Camden Cycling Campaign

4th January 2026

The Cross Camden Cycleway Engagement

Figure 1. The 3 Parkway junctions

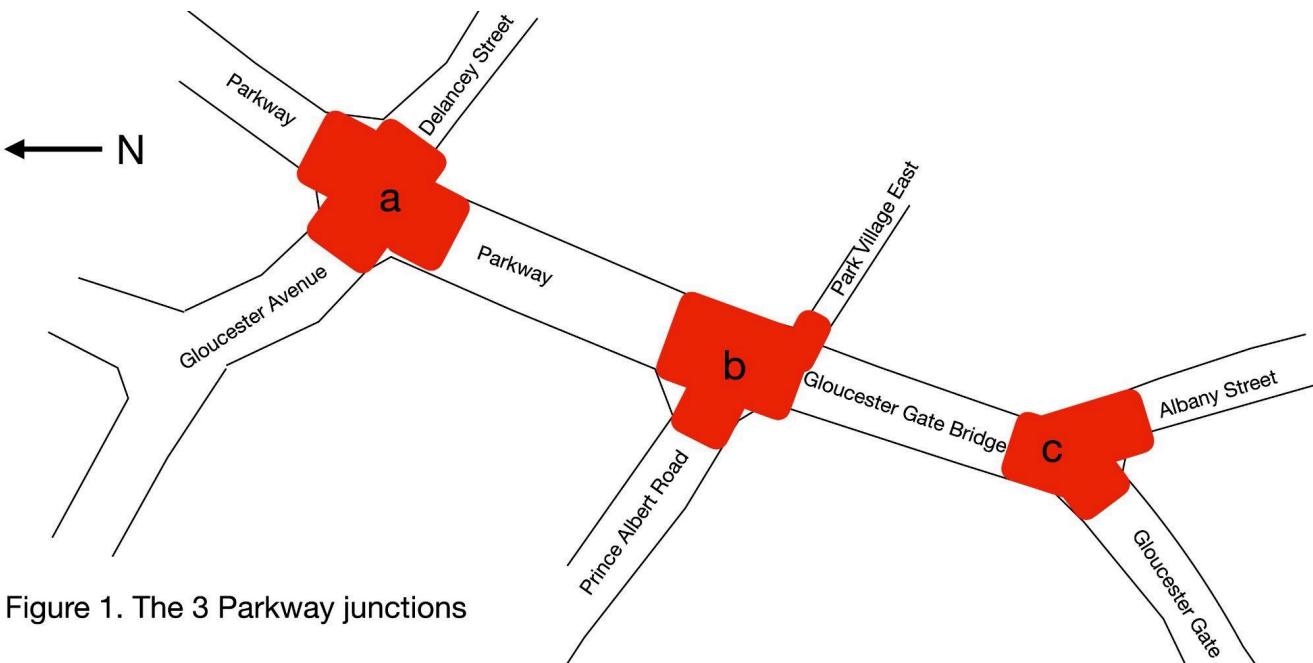
In Figure 1, the junctions **a** and **b** are needed for the alignment of the Cross Camden Cycleway, while junction **c** connects Albany Street to the Cross Camden Cycleway and to the Regent's Park Outer Circle.

- Parkway - Delancey Street - Gloucester Avenue:** we are very happy to have heard hints that this may be a second Circulating Cycle Stage junction but with cycles on the outside path (in contrast to Agar Grove where they will be on the inside path). Circulating Cycle Stage junctions work very efficiently because cycles go at the same time as pedestrians. We are very supportive of this idea.

- Parkway - Prince Albert Road - Park Village east - Gloucester Gate bridge:** for the Cross Camden Cycleway we are expecting a very smooth two-way transition between Prince Albert Road and the Delancey Street junction (**a**). However this junction should also:

- allow access to and from the Albany Street junction (**c**) e.g. to include journeys to and from Gloucester Avenue at junction (**a**);
 - Provide access to Park Village East and consider whether the very-useful addition of two-way cycling would be feasible.

- Gloucester Gate bridge - Albany Street - Gloucester Gate:** we see this junction's main function as connecting the agreed Albany Street cycleway to the rest of the cycle network via the Cross Camden Cycleway westbound or eastbound. But it should also provide access to the Regent's Park Outer Circle. Considering that the primary road alignment (A4201) is on Albany Street — Gloucester Gate Bridge and that Gloucester Gate is not a primary road, we wonder whether signals are needed. A priority junction would allow cycles to proceed through the junction without any waiting at signals, only needing to pause when pedestrians were on the crossings.

Figure 1c

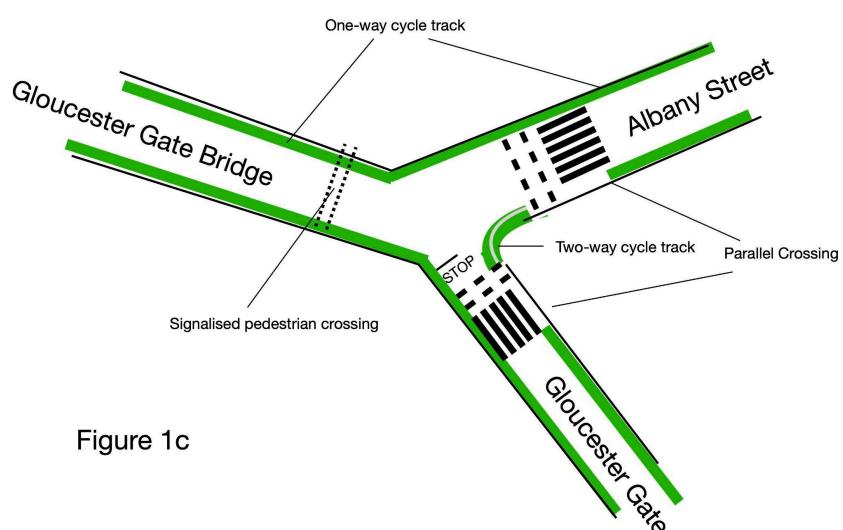
The same would apply to motor vehicles going straight ahead on the primary alignment – we believe that with about 13m width there would be room for a right turn lane on Gloucester Gate Bridge. For a priority junction, we suggest that a solution with parallel crossings similar to Market Road at York Way should be considered (see Figure 4A below). In Figure 1c we show an additional signalised pedestrian crossing over Gloucester Gate Bridge

Consideration should be given to synchronising the signals at junctions (a) and (b) so as to facilitate people on bikes passing through both junctions in one movement.

Figure 2. The Camden High Street junction

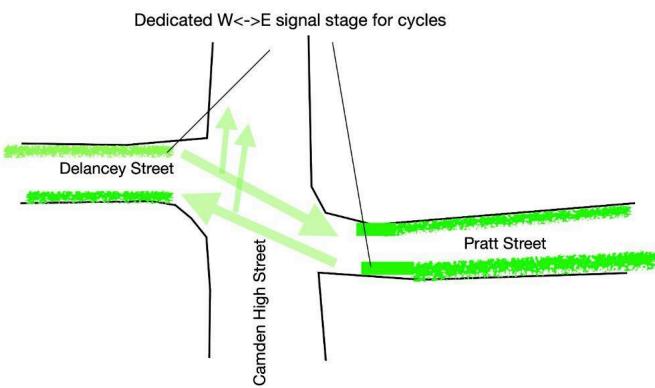
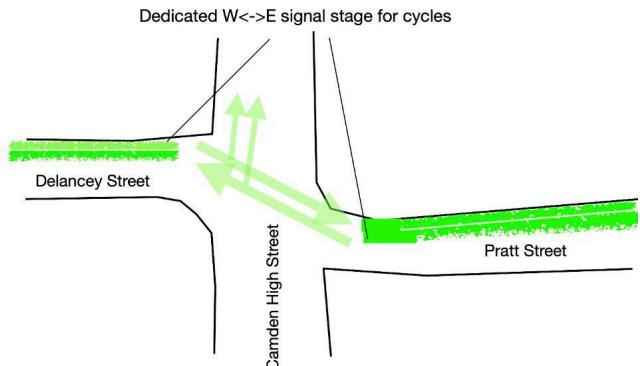
Normally we would take the position that cyclists should be able to make all possible manoeuvres across the junction without risk of conflict with motor traffic. In this case that would include northbound cycles on Camden High Street being able to access the Cross Camden Cycleway to head east or west. [The current arrangement](#) with an ASL on the left two lanes, even with an early release, would not support access to Pratt Street East; the addition of a 2-stage right turn could solve that problem but there would still be severe risk of left hook for cyclists heading into a far-side cycle track or the right-turn pocket on Delancey Street or going straight ahead on Camden High Street

We would not want a lack of improvements on this approach to delay progress on the Cross Camden Cycleway. Therefore we take the position that getting a safe crossing over Camden High Street should be

the target and we note that safe crossings over Camden Road and over Euston Road (both using a dedicated signal stage for cycles) have been very successful on the C6 route.

Figure 2 above shows movements on the cycleway between Delancey Street and Pratt Street and turns north up Camden High Street. The provision of a dedicated east-west signal stage for cycles would ensure that no other motor vehicle would be moving through the junction during this stage.

The fact that the motor traffic movements are one way on both northbound and westbound directions should reduce the complexity of the signalling; we therefore urge Camden to provide a dedicated east-west signal stage for cycles – they are better than gates.

Figure 3. The Bayham Street junction

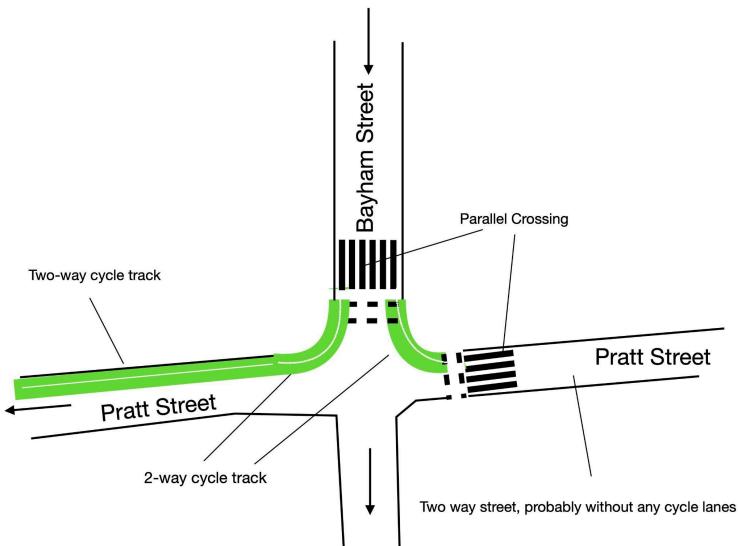
We would like to see a junction design that provides a safe crossing in both directions over Bayham Street as well as allowing the CC cycleway to be joined from the north and for people on the CC cycleway to turn south and access the Crowndale Road cycleway.

Figure 3 on the right shows how parallel crossings over Baynes Street and over Pratt Street would work with a two-way cycle track on the north side to the west of Baynes Street.

With one-way cycle tracks to the west of Baynes Street an additional parallel crossing would be required for crossing Pratt Street on the west of the junction.

Figures 4A and 4B parallel crossings at priority junctions

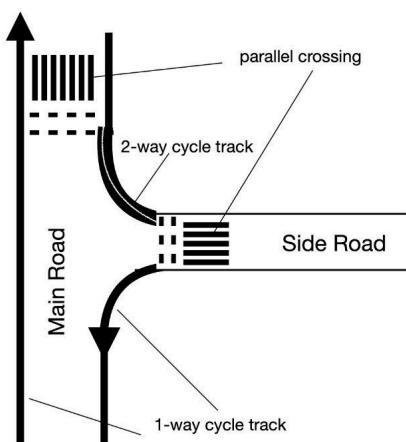
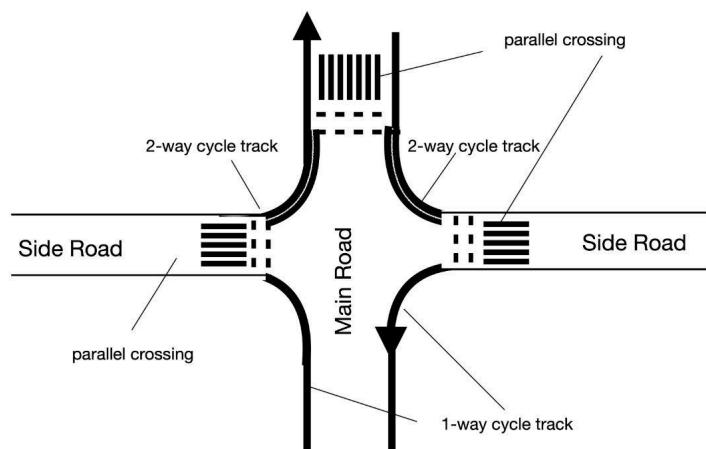
Mornington Terrace junction at Delancey Street: We would like to see parallel crossings deployed to provide safe and convenient access between the cycle lanes and Mornington Terrace (e.g. see Figures 4A and 5A below) with one crossing over Delancey Street and another over Mornington Terrace with a short section of two way cycle track round the corner between the crossings.

We would like to see a solution for cross-road priority junctions using parallel crossings but without using any 'shared space' – i.e. space shared with pedestrians. See Figure 4B below in which one parallel crossing helps cyclists over Delancey Street and the other two are used to cross the side roads adjacent to each cycle track. Figure 5B is a variation of 4B that caters for a two-way cycle track on the north side of Delancey Street.

A very useful exemplar of a T-junction is the recently reconstructed junction of York Way / Market Road. See [this photo](#) and our diagram in Figure 4A below.

For a crossroads see [this photo](#) of the new parallel crossing at York Way/ Randalls Road / Beaconsfield Street which supports the first but not the second task. Our diagram 4B illustrates how both tasks could be supported.

When a parallel crossing is used for task 2 it should be placed as close to the junction as possible.

Figures 5A and 5B shows similar arrangements but with a two-way cycle track on the main road

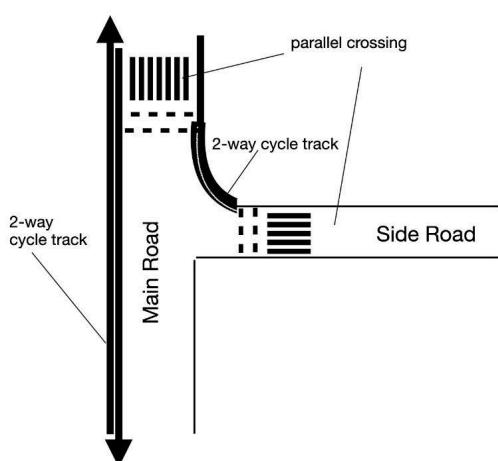
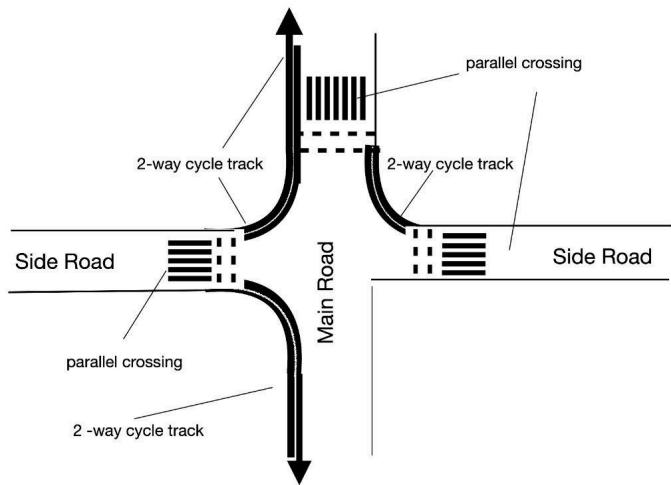
In the case shown in Figure 5B the parallel crossing over the main road is placed to support clockwise movements around the junction which is beneficial for those on the cycle track and on the side road adjacent to the cycle track. Anticlockwise movements would benefit only movements from the side road opposite the cycle track.
